## **Response to RAI-11 Regarding Background Radiological Characteristics**

**Technical Memorandum**  
**Response to November 16, 2017 Public Meeting Conference Call to Discuss RAI**  
**Responses with Lost Creek ISR: RAI-11 (b, c, d)**

**December 11, 2017**

**Figure 2. Probability Plots of the 2006 and 2013 Gamma Survey Data**

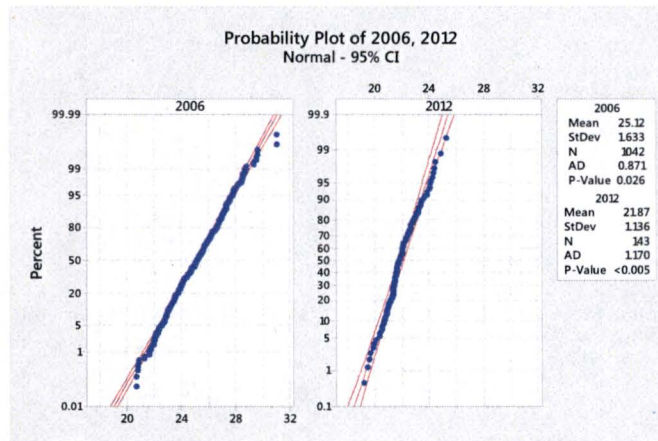
Tetra Tech's Response #2 is related to the NRC's request on Page 11 of ML17324B356 for additional information related to the calibration of the UTV-based radiation measurement instruments. RAI-11(b) *Gamma scans* specifically states: (2) *The correlation between previous UTV-based gamma scans (2008 Tech Report volume 2 section 2.9) and the 2013 UTV-based scans (2017 Tech Report section 3.12 and D-10) is not well documented.* The NRC requested Lost Creek ISR, LLC to provide additional information concerning the calibration of the UTV-based radiation measurement instruments used for exposure rate measurements. The request also notes that characterization of background radioactivity levels is needed for several radionuclides in addition to radium-226.

Tetra Tech concluded in Section 5.0 of the 2013 Baseline Study Report that the difference between the average of measurements (2006 and 2012) was 13.8%. Therefore, the gamma exposure rates were corrected by this normalization factor to allow direct comparison of the data sets. The purpose of normalizing the data in this way is to allow use of the 2006 HPIC and gamma-soil-radium correlations, which could then be applied site wide to meet the objectives of the scope of work. An analysis was performed to show the distribution of 2006 vs. 2012 gamma measurements. Figures 2 and 3 present the normal probability and frequency histograms comparing the two surveys.

**Figure 5. LCE Gamma Exposure Rates (2012 Scan Results)**

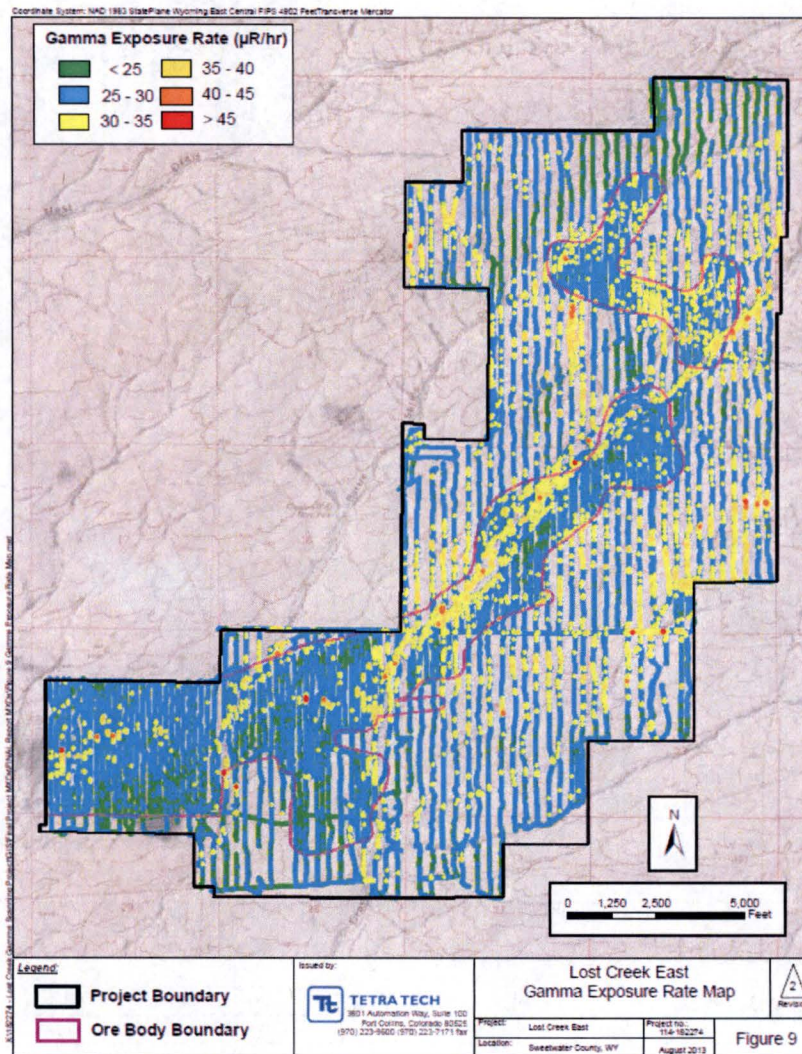
The NRC stated that data gaps were present in the LC East (LCE) information concerning preoperational monitoring. Discussion during the November 16, 2017 conference call provided additional detail concerning the NRC observation. NRC staff noted that, while the original Lost Creek report (2006) provided data for a set of soil samples complying (as feasible) with NRC Regulatory Guide (RG) 4.14 (1980), the LCE data (2012) listed samples taken only at the air monitoring station locations. The NRC requested that additional soil samples be taken over the LCE area, using a system and number of samples to be proposed by Lost Creek/Tetra Tech staff.

Because the LCE expansion area will contain no facility corresponding to a “mill” (liquids extracted from the LCE area will be processed at the facility located in the original LC area), the RG 4.14 guidance cannot be applied to the LCE area. Therefore, to develop the requested additional soil sampling regime, we propose instead to utilize the 2013 report’s LCE gamma scanning data set to identify locations of interest for soil sampling. This approach focuses sampling on areas that indicate the presence of naturally occurring radioactive material. Data from such locations may prove to be of value in later years, during site closure operations. Figure 5 presents the raw gamma exposure rate data from the 2013 LCE report. Figure 6 presents the proposed soil sampling locations.
